GUAM ENVIRONMENTAL PROTECTION AGENCY • *AHENSIAŇ PRUTEKSIÓN LINA'LA' GUÅHAN*

FROM: Chief Engineer, Guam Environmental Protection Agency

SUBJECT: Site Inspections at Samsung Mangilao Solar Project Site, July 23 and 18, 2021

Overall site plan, but note that the designs of Pond 3 (center bottom) and Pond 4 (right bottom) were changed, and a Pond 5 was added (upper annotated discharge location) w/ GEPA approval (see additional photos)

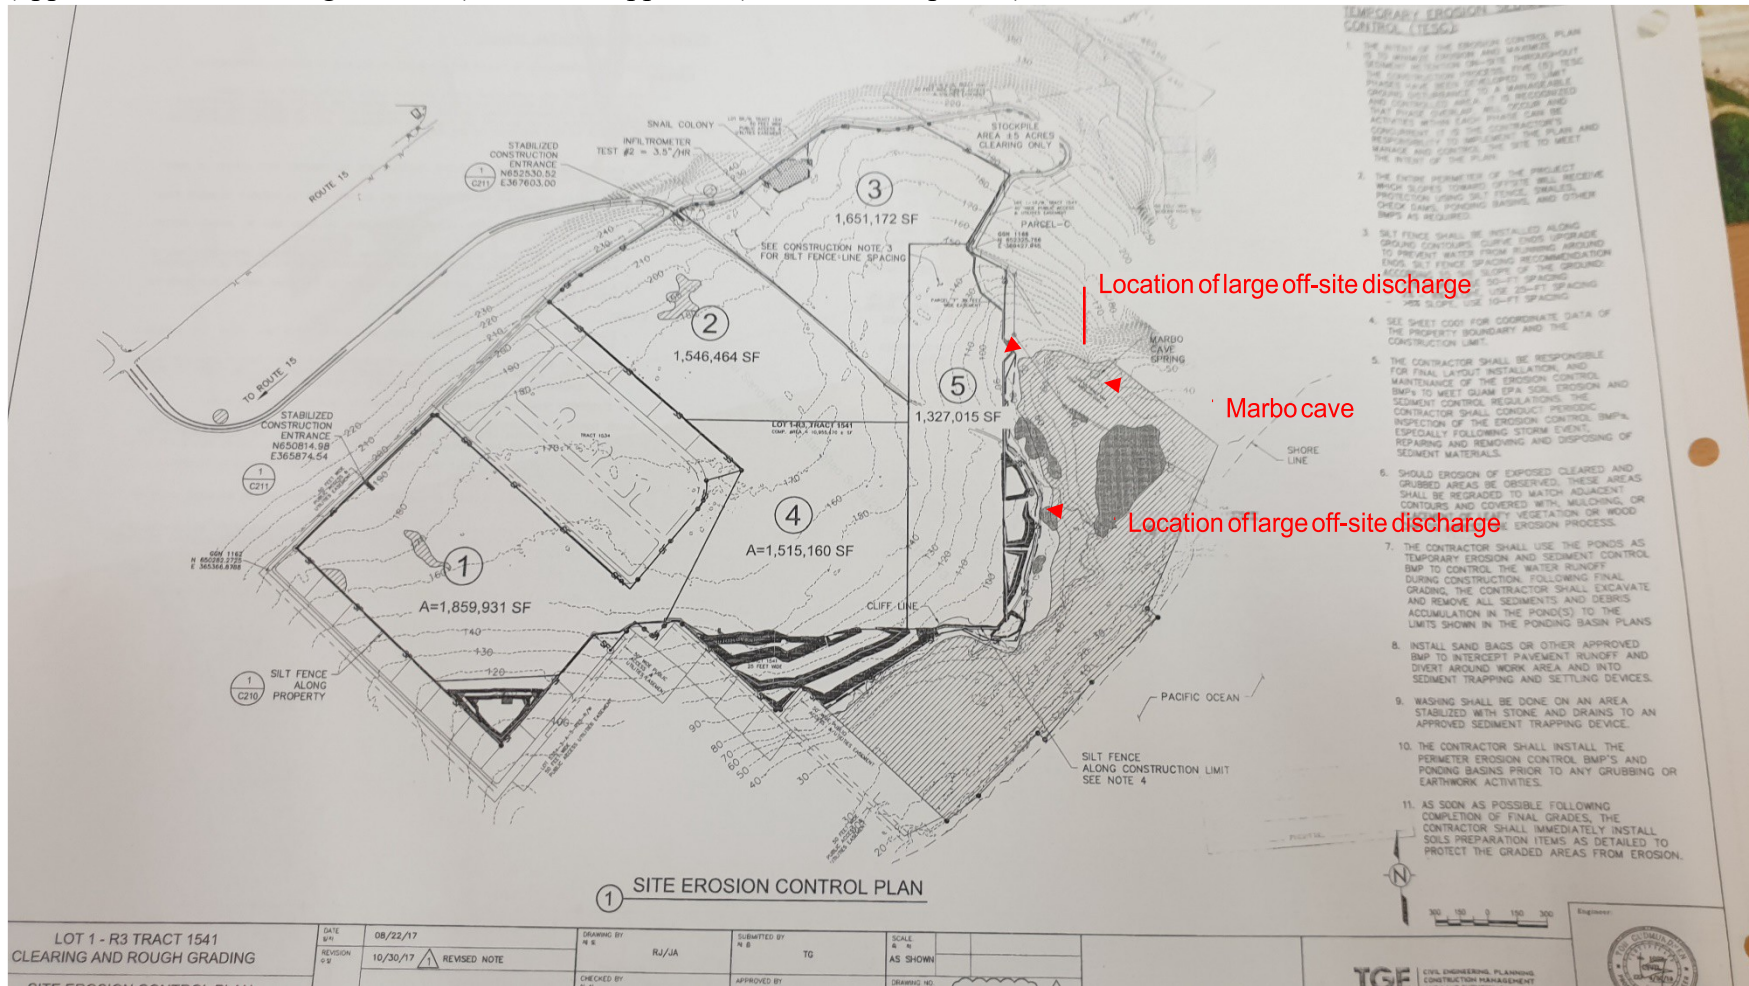
Annotations in red added to highlight location of discharges toward Marbo Cave (upper) and from Pond 4 area (lower), which was the subject of the complaint.

ADDENDUM: Inspection of Pond 5, July 28, 2021. Excerpt from revised E&SC plans approved by GEPA January 4, 2021, adding Pond 5 to the area which would discharge toward Marbo Cave:

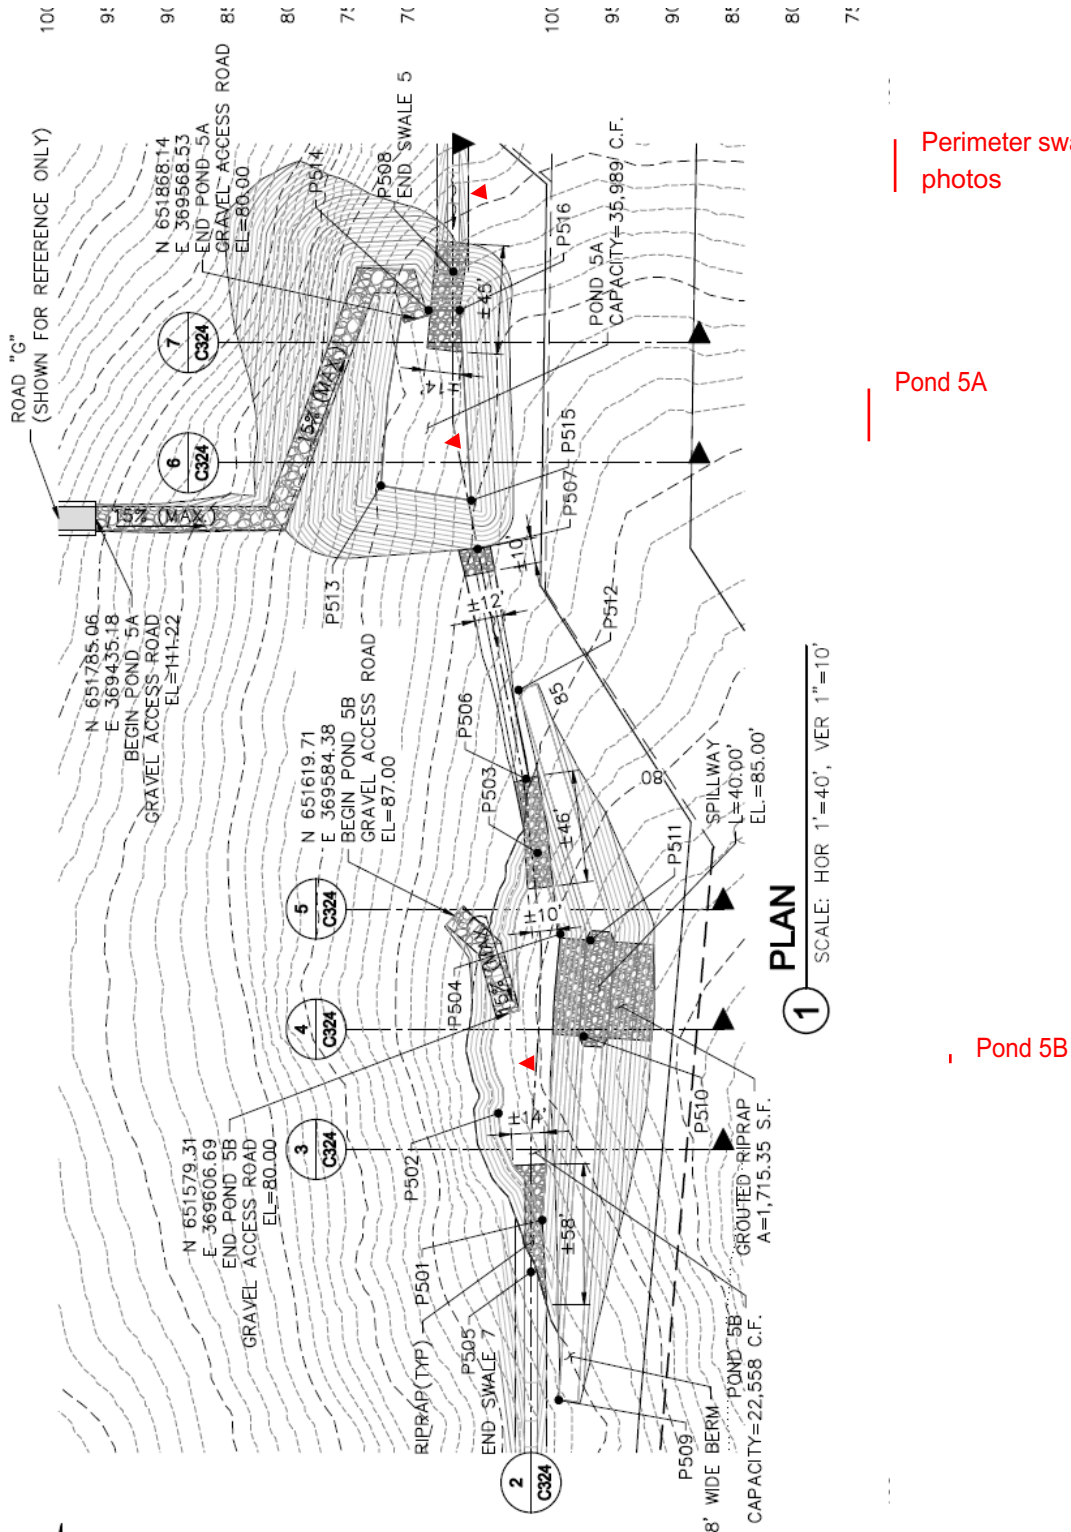
The location of the Marbo Cave discharge and Pond 5, showing activity underway to install E&SC measures on July 28, 2021:

The beginning of construction work for Pond 5B. The soil embankment is to delineate a temporary storage pond, while the permanent embankment is installed just beyond (to the right). Base preparation for the permanent embankment has begun, but emplacement and compaction of embankment fill had not yet begun (July 28, 2021):

Pond 5A excavation, which according to Samsung site personnel was begun in June. However the excavation is not yet connected to the site swale, so mass runoff is unable to enter the basin. Sedimentation pictured is from incidental runoff that the excavation collected due to its location (July 28, 2021):
